## MEMORANDUM

**DATE:** September 13, 2018

**SUBJECT:** 264 Old Connecticut Path (Wayland High School), DEP File No. 322-928 | 412  
Commonwealth Road (Loker Conservation and Recreation Area), DEP File No.  
322-XXX

Figure 1: Zinc analytical data in groundwater collected from the Fenn School

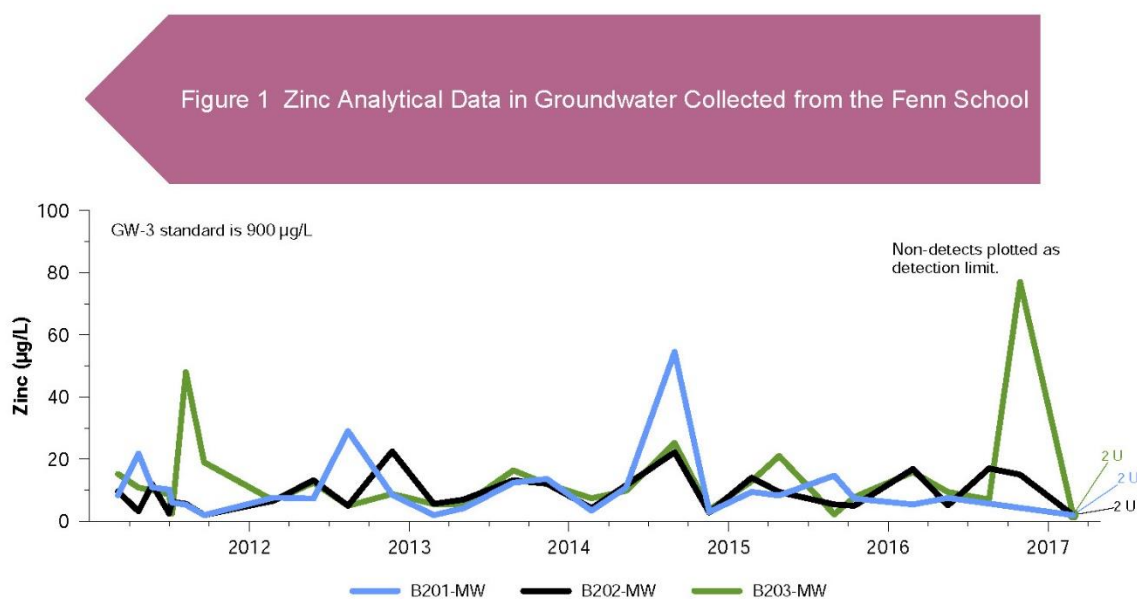
Mr. Sax asserts on slide 3, "Zinc leached from crumb rubber is toxic to wetlands aquatic life." He goes on in slide 5 to present literature data that shows zinc leaches from crumb rubber at concentrations up to 488 ug/L (which was rounded up to 500 ug/l in a review article). He then compares that data to the EPA Ambient Water Quality Criteria (AWQC) of 120 ug/L and concludes on slide 7 that, "Zinc levels will exceed EPA standards for aquatic life." Note that the EPA AWQC is a surface water standard.

Weston & Sampson has partnered with another environmental firm that has completed a 5-year study of leaching potential of a crumb rubber field at the Fenn School in Concord, Massachusetts. This study has gone through peer review and is scheduled to be published later in 2018. The Fenn School field uses a crumb rubber inlay similar to what is proposed for the Wayland artificial fields. A graph displaying five years of groundwater data collected from monitoring wells proximate to and down gradient of the Fenn School field that was analyzed for zinc as shown in Figure 1. Groundwater was collected on a quarterly basis, (i.e., 4 times per year) to account for changes in the water table that might occur seasonally. As can be seen in Figure 1, the concentrations of zinc over 5 years has never been greater than 80 ug/L in groundwater; well below both the EPA AWQC and the MassDEP Method 1 GW-3 standard.

Weston & Sampson also proposes to install monitoring wells in the areas surrounding the Wayland fields and to perform similar monitoring, as approved by the town, to ensure that any concentrations that may be observed in leachate from the artificial fields are at an acceptable concentration and do not affect any nearby aquatic receptors nor the drinking water wells in the town.

Figure 2: Artificial Turf Specification Details

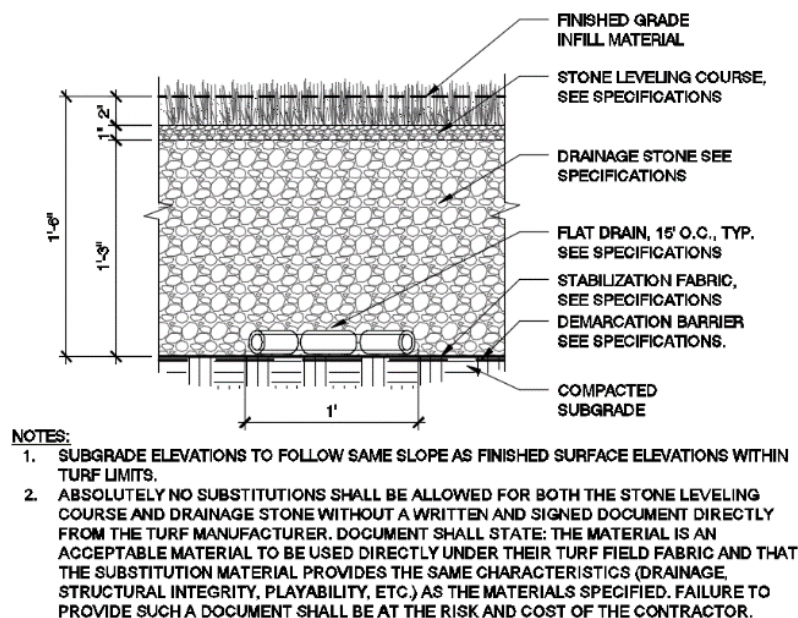
Mr. Sax presents some information on water flow at the Loker Conservation and Recreation Area field site on slide 2 and claims that the field design exacerbates zinc leaching on slide 6. Mr. Sax's claims that: 1) "Crumb rubber will marinate in rainwater for extended periods;" 2) "On warm sunny days crumb rubber will reach 140F to 160F like putting water crumb rubber mixture in a crock pot set on medium;" 3) "Zinc concentration will increase as water evaporates on hot days...like maple syrup;" 4) "Zinc concentration increases with each rainfall and evaporation cycle;" and 5) Major rainstorm will flush Zinc laden water into Loker and Willow Brook wetlands.

The objective of artificial turf construction is to pass water through to recharge the aquifer and therefore not create surface water from precipitation. A failsafe or relief valve built into the system for large precipitation events is the drainage pipe that is constructed at the bottom of the 15-inch thick drainage stone. If the precipitation event is sufficiently intense as to overload the native material below the field, the drainage pipe would be accessed by rising groundwater to relieve the overflow. These drainage pipes are flat perforated pipe that collect the rising groundwater and direct it (now as surface water) into

the wetlands to the north of the field. This was the design for the previous field and is the proposed design for the proposed field.

The crumb rubber does not "marinate in water" nor is there an area within the system that collects water with the crumb rubber. Crumb rubber remains in-laid in the carpet of the artificial turf. Rain water is stored in the stone drainage layer below the field that does not contain crumb rubber and should percolate under the field into groundwater. If there is any water remaining in the crumb rubber on the field, it will evaporate in the sun.

Figure 3: Happy Hollow Wellfield Zone II & Surficial Geology

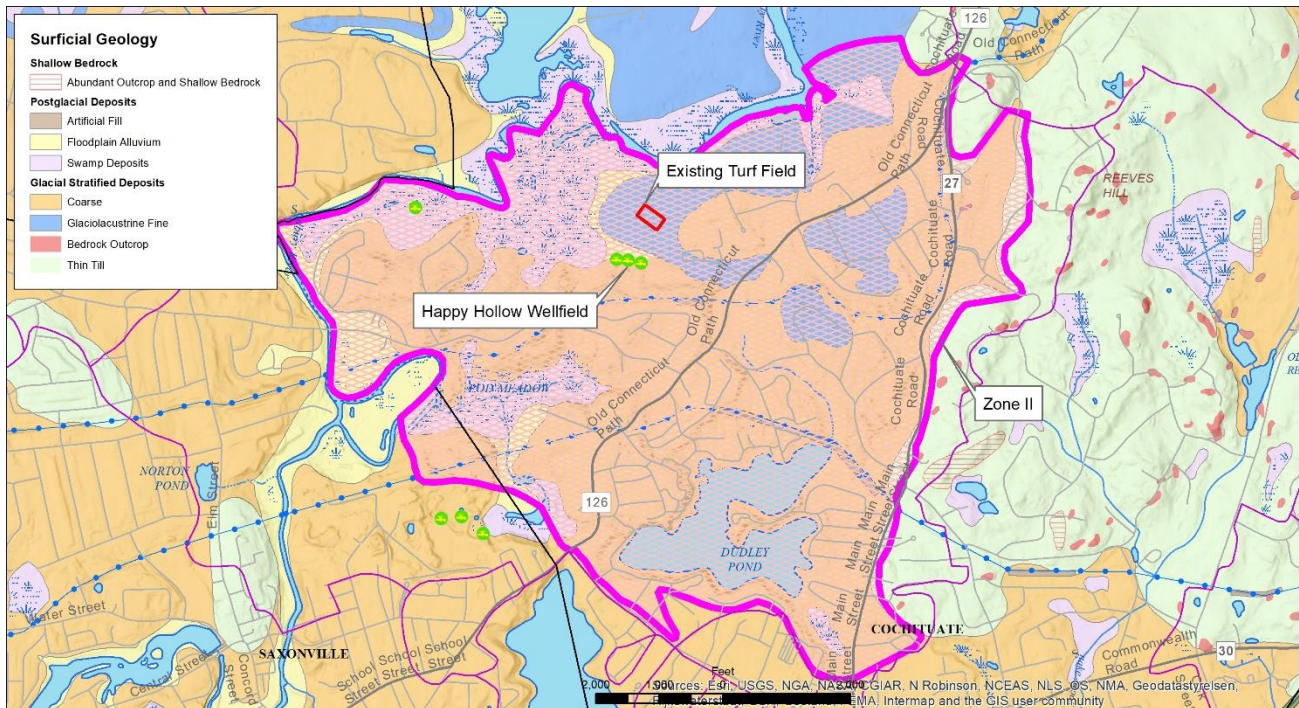
- 1) how drainage in the turf field is designed to function
- 2) the groundwater flow regime within the Zone II wellhead protection area of the Happy Hollow Wellfield
- 3) the results of water quality testing at the Wayland High School site for the ten years it has been in place
- 4) a discussion of additional water quality concerns raised in the letter.

In the case of the Happy Hollow Wellfield, groundwater under non-pumping conditions, flows regionally towards the Sudbury River located to the north of the wellfield. Locally, in the area of the turf field and wellfield, the groundwater flow direction is to the west towards the bordering vegetated wetlands that about the Sudbury River. Under pumping conditions, groundwater head contours are altered as the withdrawal creates a cone of depression around the wellfield, establishing a groundwater gradient towards the well. Using the head contours developed from observing the groundwater elevation in a

monitoring network surrounding the wellfield during a long-term pumping test, a Zone II is delineated and shown on Figure 1 below.

The Zone II in Figure 3 is overlain on a surficial geologic map. This map was constructed to assist the reader in understanding that the Happy Hollow Wellfield area is largely underlain by coarse stratified drift deposits of high permeability (defined in orange on the map). Additionally, the Zone II is specifically bounded by 1) the Sudbury River to the north as a downgradient stagnation point, 2) till (low permeability) deposit boundaries to the north and east, 3) and a sub-basin divide to the south and west. Using the Zone II and the groundwater contours (under pumping conditions) as a guide, one can define the percentage of flow from each area of the aquifer. Using this methodology, it is estimated that the area defined by the existing (and proposed) turf field contributes approximately 0.6% of the flow to the Happy Hollow Wellfield. Considering that the wellfield holds a permit from the DEP to withdraw up to 1.411 Million Gallons per Day (980 gallons per minute), this represents just under a 6 gpm contribution to the pumping rate of the Wellfield. If we consider the fact that a significant portion of the field is underlain by glaciolacustrine clay deposits (defined in blue in Figure 3) of low permeability, this value is most likely lower. This evaluation is supported by the 2010 Study funded by the Wayland Wellhead Protection Committee that Mr. Sciacca references. The study concludes that, *“Under pumping conditions, most of the groundwater that reaches the wells originates from the east and probably south of the Happy Hollow wells. The groundwater contribution from the area of the High School tennis courts and football field is expected to be minor, transmitted only through a thin upper layer of sand that overlies thick clay deposits.”*
